**CAPAMI LTD.**

**OLDCOURT LAP LANDS,  
FIRHOUSE, DUBLIN 24**

**ENGINEERING  
PLANNING REPORT**

Project Name	Oldcourt LAP Lands, Firhouse, Dublin 24
Document Title	Engineering Planning Report
Document Number	P211102-PIN-RP-00-C002-V2

Figure 4-1: Bio-retention tree pit with bypass/overflow gully downstream of kerb opening.

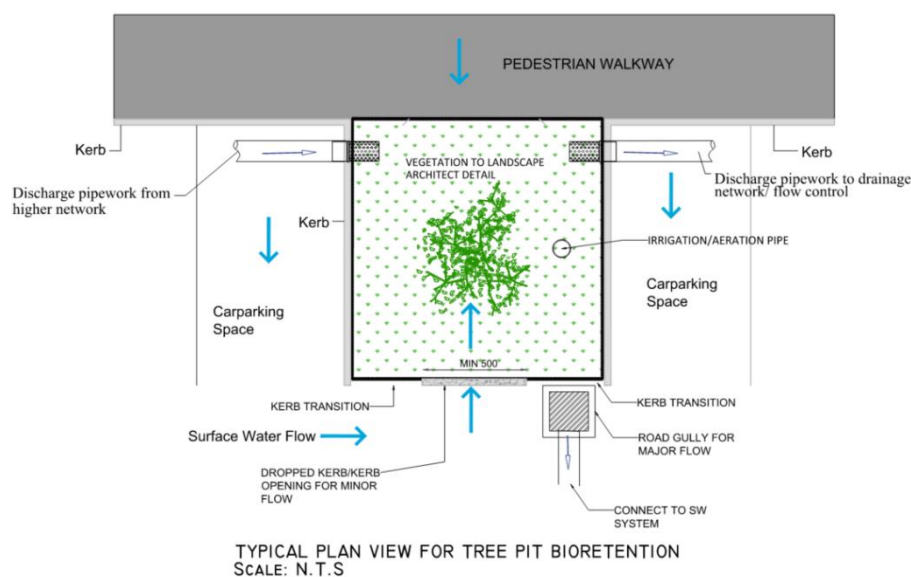
1.5 Clarify on a drawing how surface water from roads will flow into SuDS features and not gullies. Road gullies and pipes can be used but only where SuDS is not feasible. Examine if surface water pipes can be replaced with SuDS such as Swales or other such SuDS features.

Response: It was discussed and agreed upon "in principle" during the meeting with SDCC Water Services on the 13<sup>th</sup> of May 2024, that, where possible, the surface water runoff from road surfaces shall discharge directly into SuDS features? (bio-retention tree pits, bio-retention raingardens, swales and land drains). In areas where runoff drains directly into SuDS via kerb openings, drainage gullies may be provided downstream of the kerb opening as a redundant capture device. This ensures that in higher order storms, any surface water runoff that may potentially bypass SuDS inlets, is adequately captured and conveyed to the attenuation basins. The subject site is particularly susceptible to surface water runoff, with high velocity on roads due to the steep gradients of the roads, in which instance the overshooting of kerb openings is more likely. Furthermore, it was agreed that gullies shall be placed above ramps in order to prevent localized low points at the head of the ramps. A detail of the gullies located downstream of a kerb opening is shown below.

Figure 7-2: Extract - P211102-PIN-XX-XX-DR-C-00220-S2 PRE-DEVELOPMENT FLOW ROUTE ANALYSIS

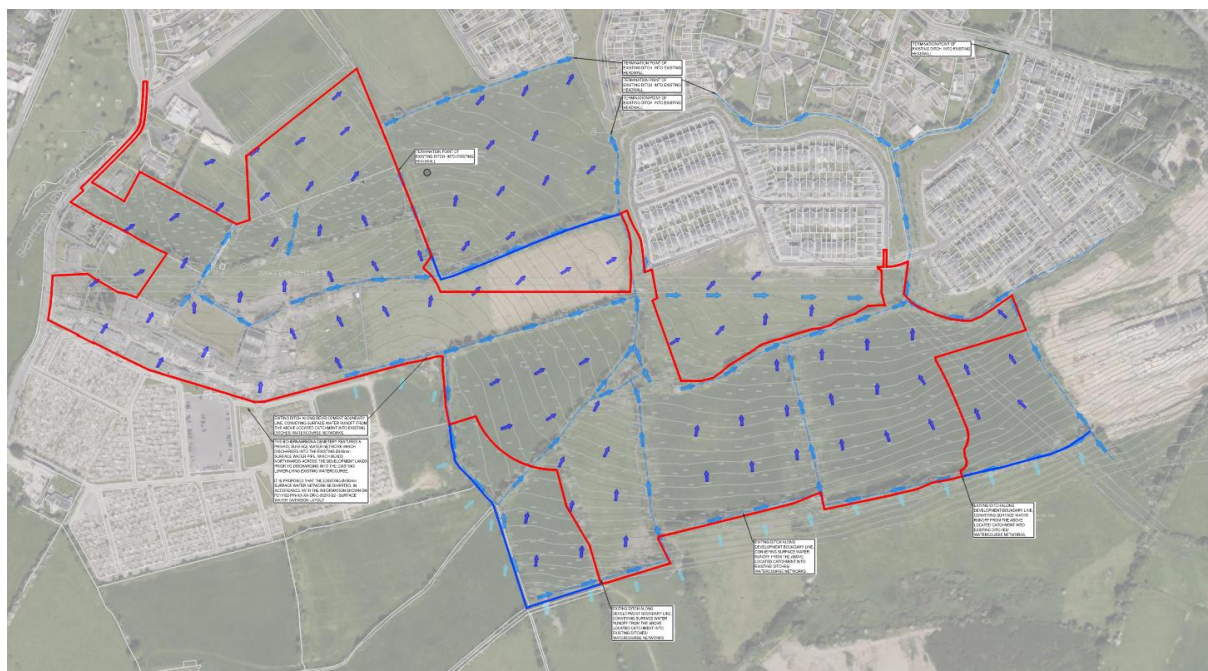
1.2 There is no flow route analysis proposed for the development. Submit a drawing showing the direction of flow of surface water on site pre-development and post development. The surface water flow routes routes post development should correlate closely with pre development flow routes as much as possible.

Response: A pre-development flow route analysis was completed and issued to Brian Harkin of South Dublin County Council Water Services on the 25<sup>th</sup> of July 2024, prior to the planning submission. Detailed pre and post development flow route analysis's can be found in the drawings listed below:-

Figure 7-3: Existing Surface water records – SDCC GIS

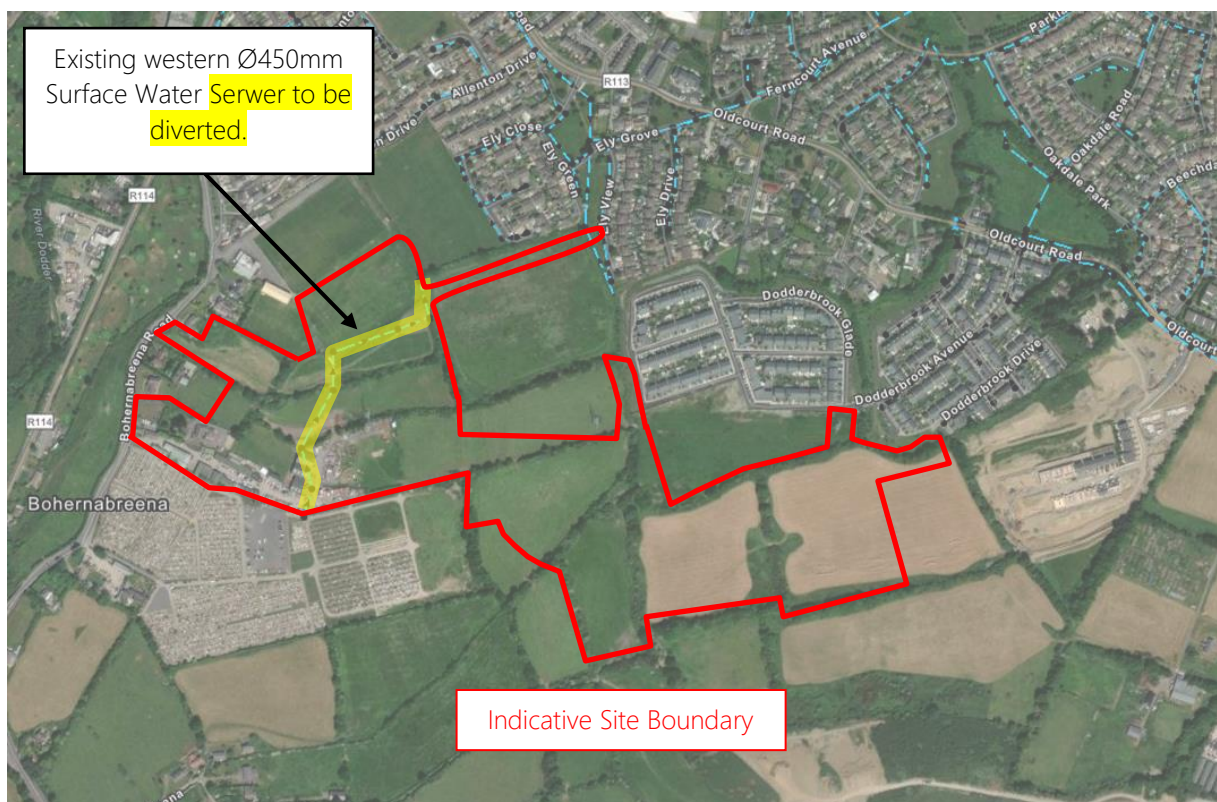
1.3 It is not acceptable to divert 450mm surface water sewer away from the current direction of flow of site and it is not acceptable to have a 90° (degree) bend on surface water sewer. The current route of the 450mm surface water sewer should remain or if there is a change in its location, then the direction of surface water flow should be improved and where possible opened up into a surface water SuDS feature, with a suitable setback distance from proposed structures.

Response: During the aforementioned meeting with the SDCC Water Services division, it was discussed and agreed "in principle" that the diversion was required to facilitate the new proposed development. Furthermore, the said diversion should remain piped, as it is currently, ensuring that the same capacity is provided. The pipe would remain piped rather than be discharged into an open ditch within the boundary of the proposed development, which would create a surface water flood risk if the upstream networks discharge into the pipeline was not attenuated.

Overall, it was proposed that the diversion remain piped to limit risk of flooding and where possible, all bends shall be approximately 45 degree, limiting the junction losses on the pipeline.

The proposed diverted surface water pipeline is setback a minimum of 5m from all proposed structures.
